Access Compliance Report

Public Rights-of-Way

(Curb Ramps)

Intersection ID: 15397	Main Street: N_WENDOVER_RD	Cross Street: N_WENDOVER_RD_RA	Location: E
ADA ID: 5092D75A1622	Ramp Type: Perp	Initial Pass/Fail: Fail	Overall Compliance: No
		Severity Score: 10

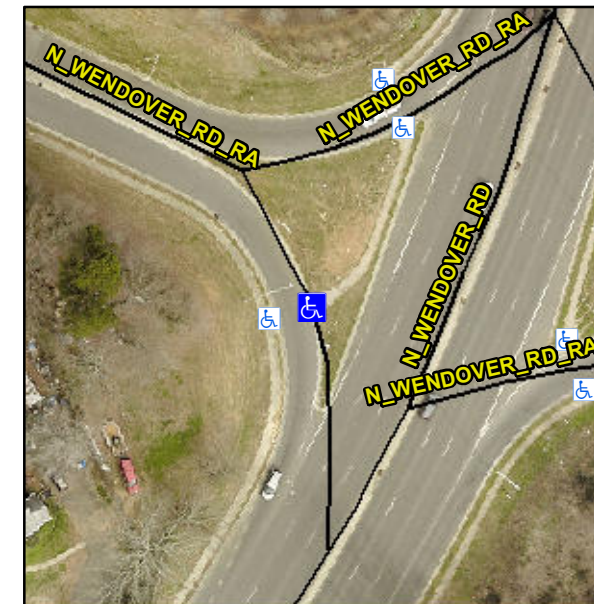
Not Found, R304.5.1

Compliance	Description	Data	Compliance	Description	Data
N/A	Ramp Length (in)	79.0	Yes	Ramp Slope (%)	8.1
No	Ramp Width (in)	46.0	Yes	Ramp XSlope (%)	3.5
N/A	Flare Type LT	N/A	N/A	Flare Type RT	N/A
N/A	Flare Slope LT (%)	N/A	N/A	Flare Slope RT (%)	N/A
N/A	Flare Traversable LT?	N/A	N/A	Flare Traversable RT?	N/A
N/A	Landing Length (in)	N/A	N/A	DWS Provided?	N/A
N/A	Landing Width (in)	N/A	N/A	DWS Contrast?	N/A
N/A	Landing Slope (%)	N/A	N/A	DWS Length (in)	N/A
N/A	Landing X Slope (%)	N/A	N/A	DWS Full Width?	N/A
N/A	Landing Curb? (Y/N)	N/A	N/A	DWS Offset (in)	N/A
N/A	Shared Landing?	N/A			
N/A	Gutter Ponding?	N/A	N/A	Gutter Slope (%)	N/A
N/A	Gutter Lip Ht (in)	N/A	N/A	Gutter X Slope (%)	N/A
N/A	Painted X Walk1?	No	N/A	Painted X Walk2?	N/A
	X Walk 1 Direction	To W		X Walk 2 Direction	N/A
N/A	X Walk 1 Width (in)	N/A	N/A	X Walk 2 Width (in)	N/A
	X Walk 1 Slope (%)	5.5		X Walk 2 Slope (%)	N/A
	X Walk 1 X Slope (%)	4.3		X Walk 2 X Slope (%)	N/A

Remove & Replace Entire Ramp.
